SUMMARY OF NEEDED MODIFICATIONS TO THE INTERSECTION OF CURTIS STREET AND SONOMA AVENUE

Marin Avenue/Curtis Street
Safe Routes to School
City of Albany Contract No. 14-12
Caltrans Project No. SR2SL-5178(014)

PAVEMENT DELINEATION AND SIGNAGE PLAN
CURTIS ST / SONOMA AVE

DRAWING: PD-02 SHEET No. 2 OF 3

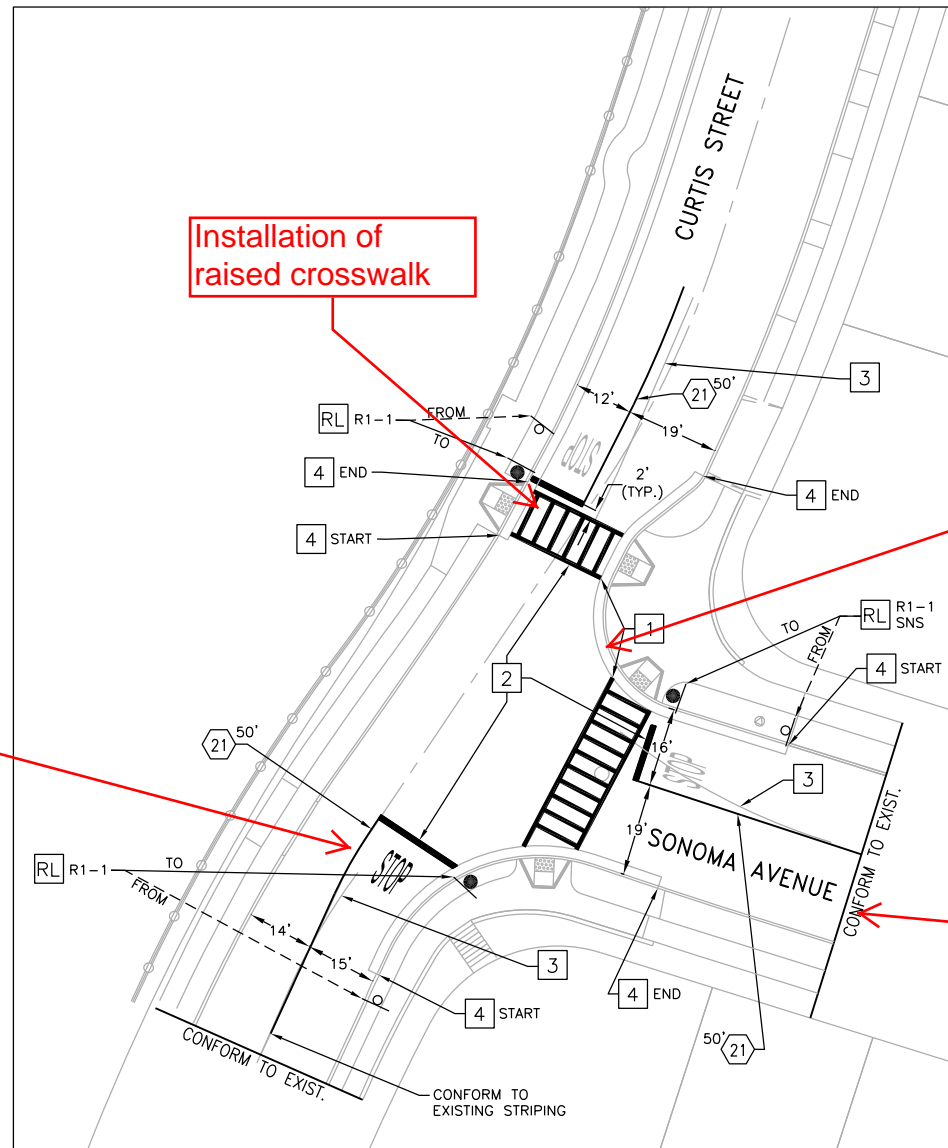
Install crosswalk and curb ramps on this leg.

Installation of raised crosswalk

Removal of northeast bulb out

ADD ALTERNATIVE BID ITEM

Installation of a speed hump between Neilson and Peralta Avenue
